Work Order ID 140290

Item Name: Replacement Skidtube (Fits LH or RH)

DRAWING NO. D2650	TITLE 206/407 SKIDTUBE ASSEMBLIES	REV. F	DART AEROSPACE LTD ENGINEERING ORDER		D.E.O. NO. D2650-F-1	SHEET NO. SHEET 1 OF 1	SCALE NTS
DRAWN	CHECKED	A.P.	MFG. APPR.	APPROVED	DE APPR.		
DATE 12.10.12	DATE 12.10.22		DATE 12.10.22	DATE 12.10.22	DATE 12.10.22

CHANGE C'BORED WELDED CROSSBOLT SPACERS TO SWAGED SPACERS

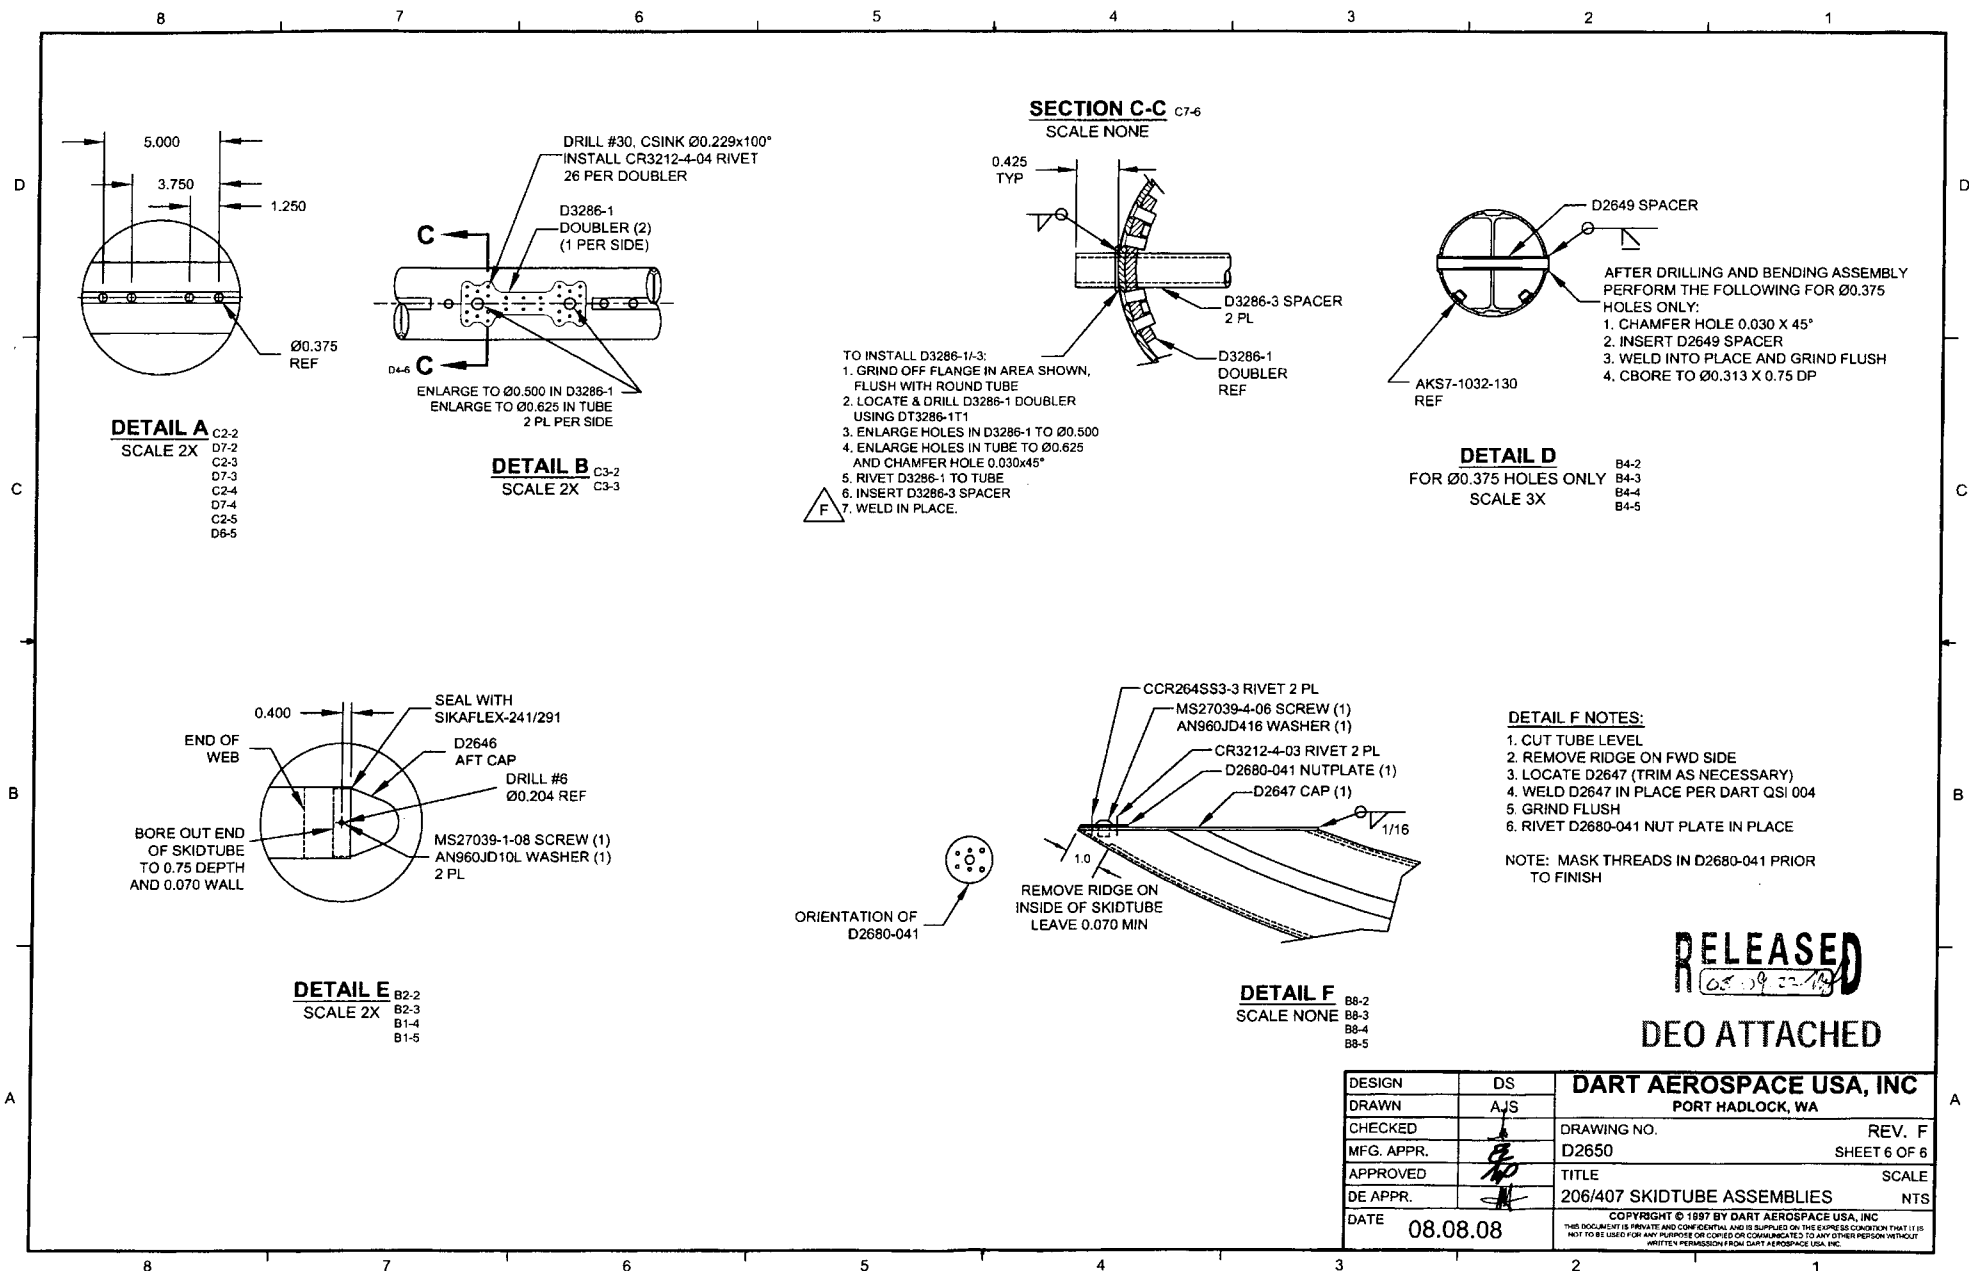
PARTS LIST IS AMENDED AS FOLLOWS:

IS:

QTY	QTY	QTY	QTY	PART NUMBER	DESCRIPTION
-1	-3	-5	-7		
1	1	0	0	D2649	CROSS BOLT SPACER
16	17	19	23	D4720-1	SPACER

WAS:

17	18	19	23	D2649	CROSS BOLT SPACER
----	----	----	----	-------	-------------------

DETAIL G

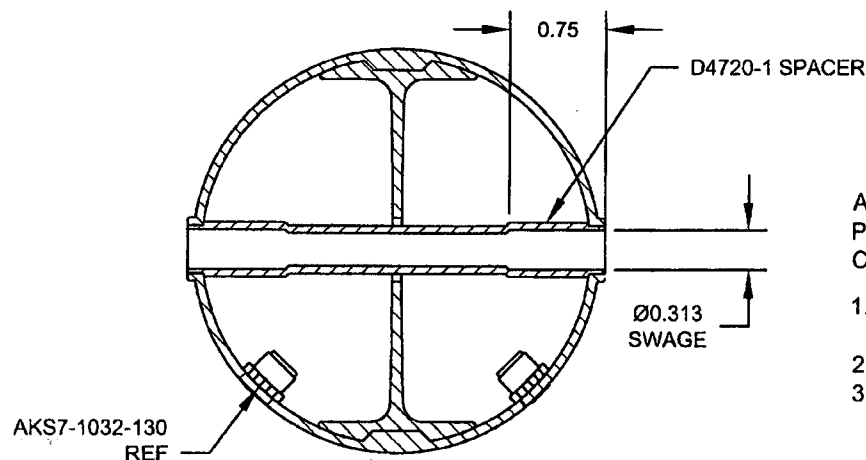
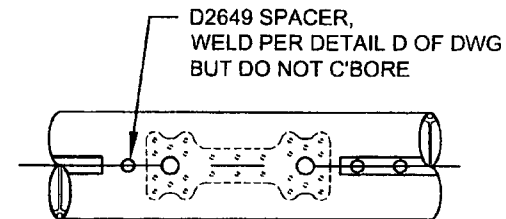
PURPOSE:

ADD DETAIL G BELOW, WHICH IS THE SAME SECTION VIEW AS DETAIL D OF DWG.
C'BORED HOLES ARE **NOW SWAGED** PER DETAIL G BELOW. FOR THE Ø0.375 HOLE THAT IS NOT C'BORED, WELD PER DETAIL D OF DWG (SEE AMENDED DETAIL B FOR REFERENCE).

FOR Ø0.375 HOLES ONLY

FOR HOLES THAT ARE CURRENTLY C'BORED ONLY

AMENDMENT TO DETAIL B
NOT TO SCALE

AFTER DRILLING AND BENDING ASSEMBLY
PERFORM THE FOLLOWING FOR Ø0.375 HOLES THAT ARE
CURRENTLY C'BORED:

1. INSERT D4720-1 SPACER, 16 PL (-1) OR 17 PL (-3)
OR 19 PL (-5) OR 23 PL (-7)
2. SWAGE TO Ø0.313 X 0.75 DP PER QSI 002
3. TRIM / GRIND FLUSH PER QSI 002
